Integration of Regulation X Software Identification Number (RXSWIN) in existing and new UN Regulations

II. Example for draft amendments to UN Regulation N° X

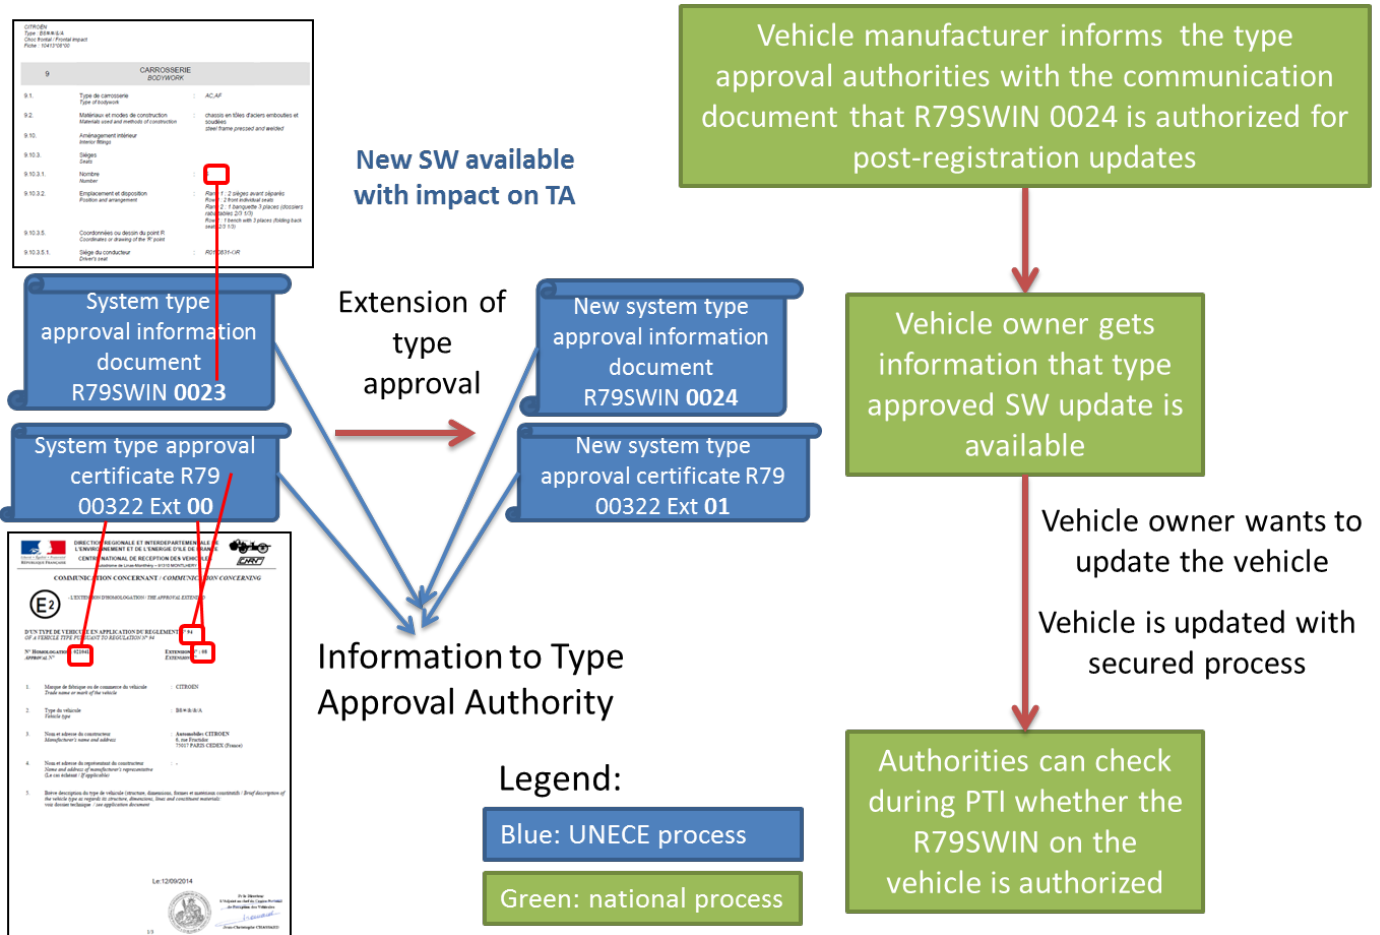
1. The members of the ad hoc session on software updates (2 August 2017) have detailed the principle of a RXSWIN “Regulation X Software Identification Number” in order to trace type approval relevant software modifications.
2. One part of the RXSWIN principle (in blue) can be integrated in existing and new UN Regulations. Another part (in green) can be added in national/regional regulations on vehicle registrations, software update of registered vehicles and periodical technical inspections:
